SS 768-WST 47X, 49X, 57X Park brake check valve may be improperly plumbed causing brakes to drag.

47X, 49X & 57X vehicles built with Park brake check solenoid part number BW 288586

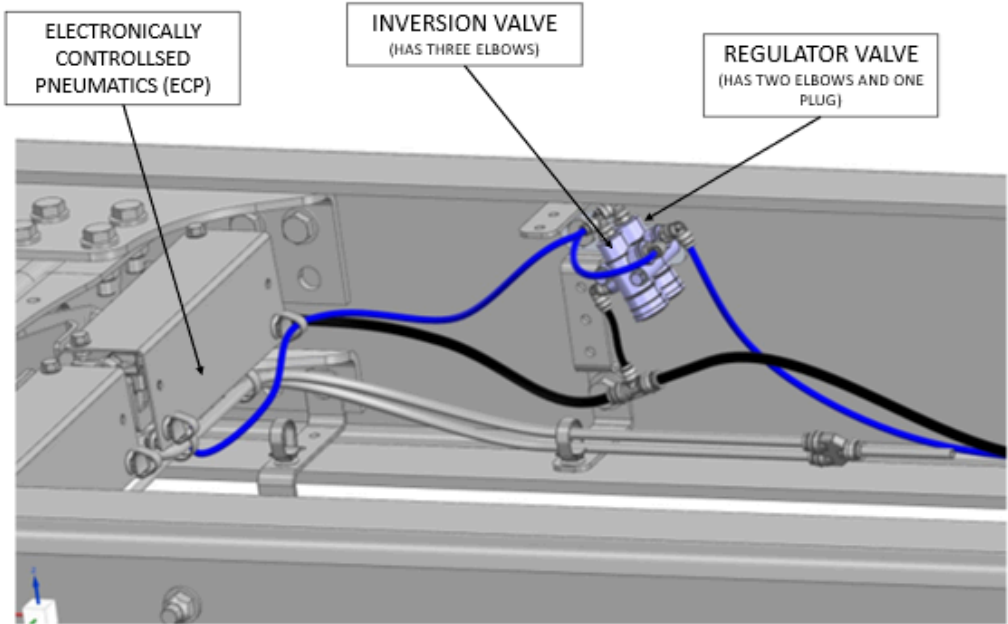
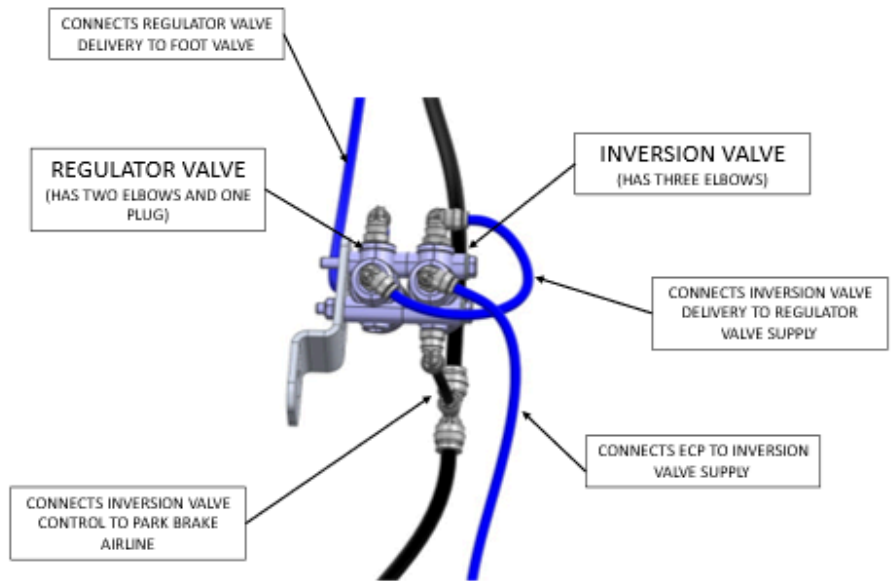
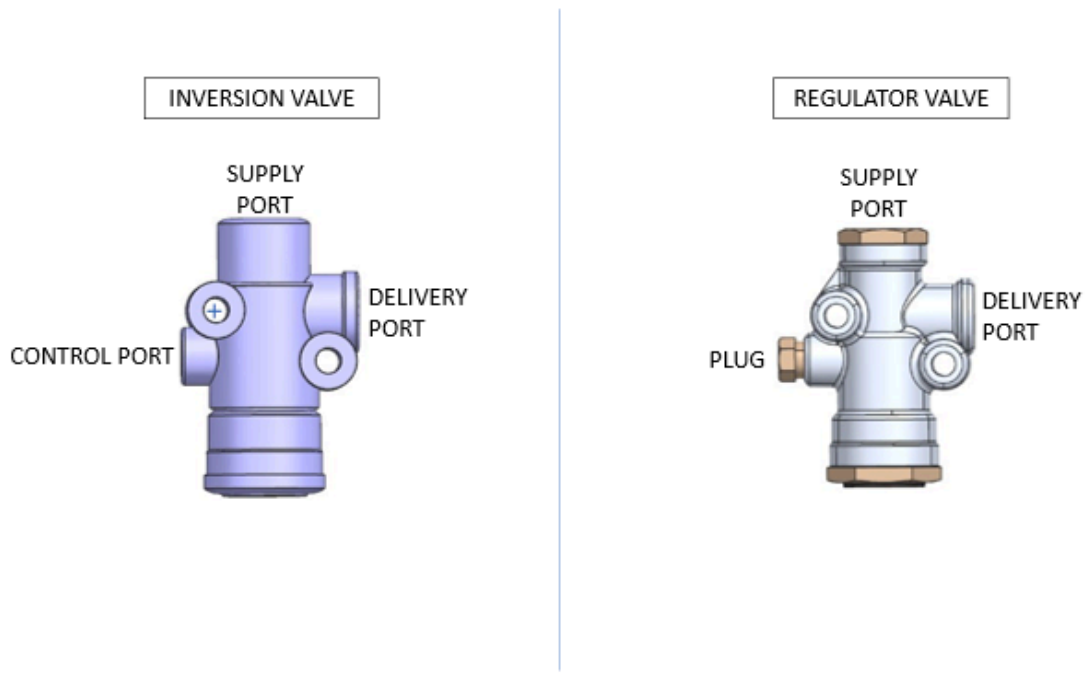
On rare occasions plants can miss plumb the park check/inversion valve and regulator valve. When trip check switch is disengaged brakes will not fully release. Techs can waist hours trouble shooting the issue if they don't know what to look for. DSM's are having the dealers correct the plumbing issue & file a DPR to the plant. This is a very simple issue to fix if you know the valve lines are swapped.

For correct plumbing schematic reference install diagram D12-28028-006 for frame rail installation and plumbing or D12-28028-004 for crossmember installation & plumbing.
